# EXPEDITED MONTGOMERY COUNTY HISTORIC PRESERVATION COMMISSION STAFF REPORT

Address: 7114 Sycamore Ave., Takoma Park Meeting Date: 3/13/2019

Case Number: 37/03-19G Staff: Dan Bruechert

**PROPOSAL:** Solar Panel Installation

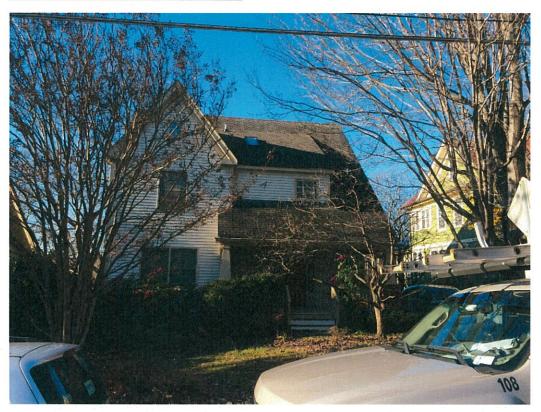
Figure 1: The solar installation at 7114 Sycamore will only be minimally visible from Poplar Ave. to the rear at a distance of nearly 300 ft. (three hundred feet).

The applicant proposes to install 37 (thirty-seven) flush-mounted solar panels on the rear slope of the roof. The electrical conduit will be installed to the rear of an existing down spout to limit its visibility. Due to the narrow setbacks of the houses along Poplar Ave., to the rear, this array will be minimally visible from the public right-of-way, nearly 300 ft. (three hundred feet) away.

Staff recommends that the Commission <u>approve</u> the HAWP application under the Criteria for Issuance in Chapter 24A-8(b)(1) and (2) and sections (c) and (d) having found that the proposal is consistent with the Secretary of the Interior's Standards for Rehabilitation (specifically, Standard 2), and therefore will not substantially alter the exterior features of the historic resource and is compatible in character with the district and the purposes of Chapter 24A; and with the general condition that the applicant shall present the **3 permit sets of drawings, if applicable to Historic Preservation Commission (HPC) staff for review and stamping** prior to submission for the Montgomery County Department of Permitting Services (DPS) building permits.
